ZONING CHANGE REVIEW SHEET

CASE: C814-2023-0027 (311-315 South Congress PUD)

Re: Update 2 Comment Response: 311-315 South Congress PUD – Planned Unit Development (“PUD”) application for the property located at 311-315 South Congress Avenue in Austin, Travis County, Texas (the “Property”).

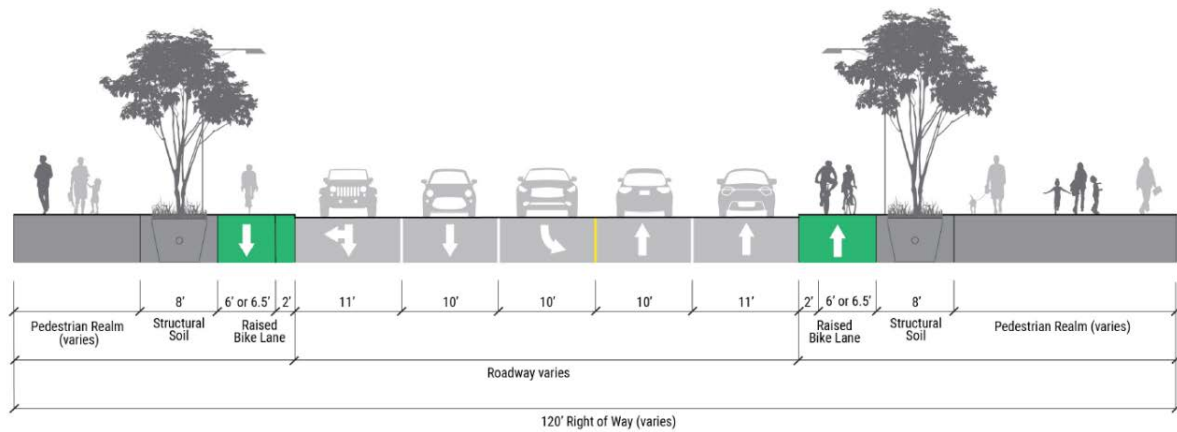
ATD 7. ATD does not recommend approval of this proposed language of Land Use Plan note #8 (noted above). To provide superiority for the streetscape, we request that the site adhere to the streetscape standards as depicted within the proposed in the South Central Waterfront Plan:

U1: Comment cleared.

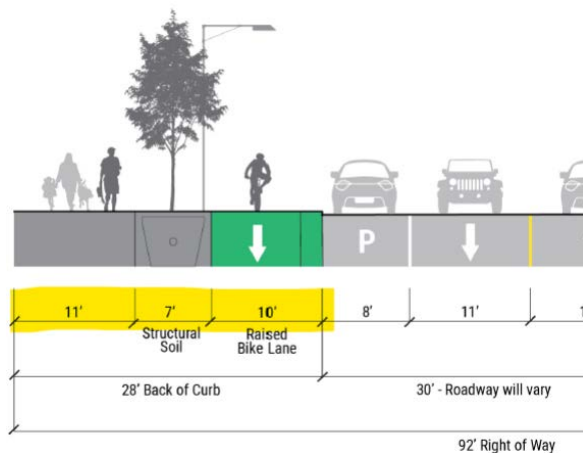
Barton Springs Road: The South-Central Waterfront plan calls for an 11' pedestrian zone and 8' planting zone, adjacent to an 8' raised bike lane behind a 2' buffer along the southwest frontage of the Barton Springs Road extension. In order to meet the superior results expected from PUDs, the site's frontage along the Barton Springs extension should provide these streetscape elements as depicted below:

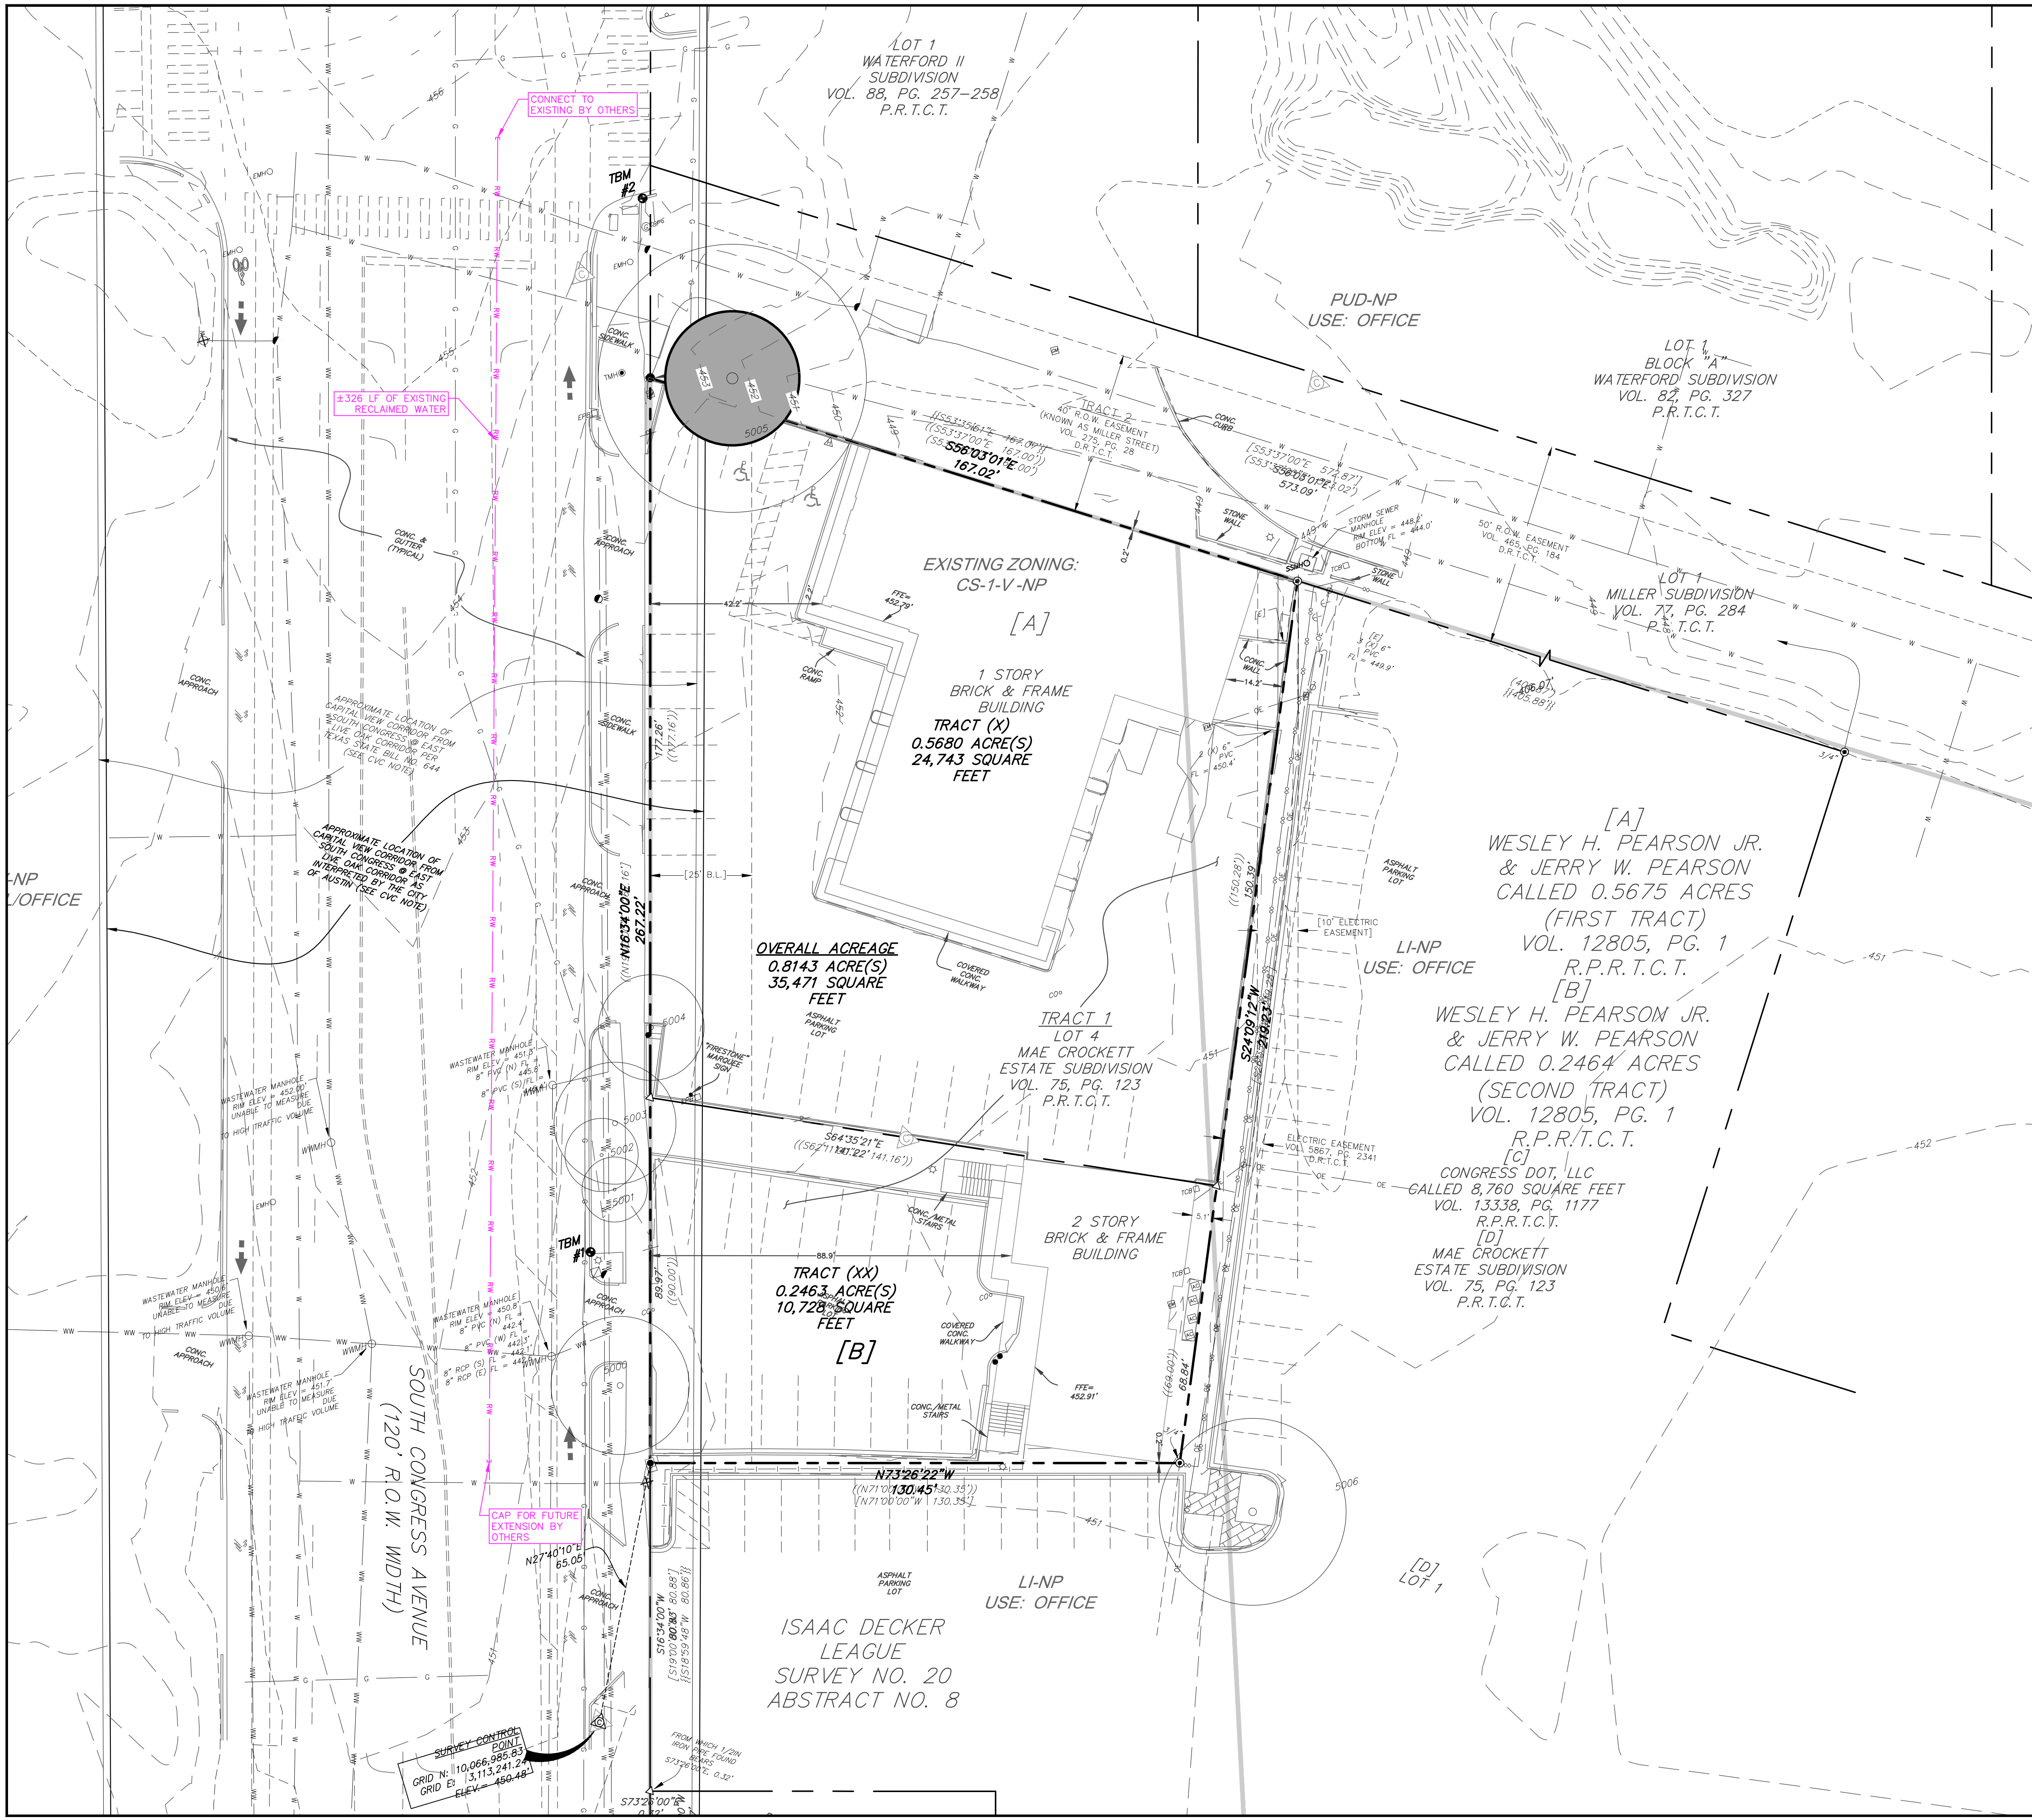
AW1. 311-315 South Congress shall build an off-site reclaimed main from the nearest, existing or planned, point of intersection of the reclaimed system to the development.

- **Update 2 Response:** A site map exhibit demonstrating the proposed location of the reclaimed water main extension along the frontage of the Property is included with this Update package.
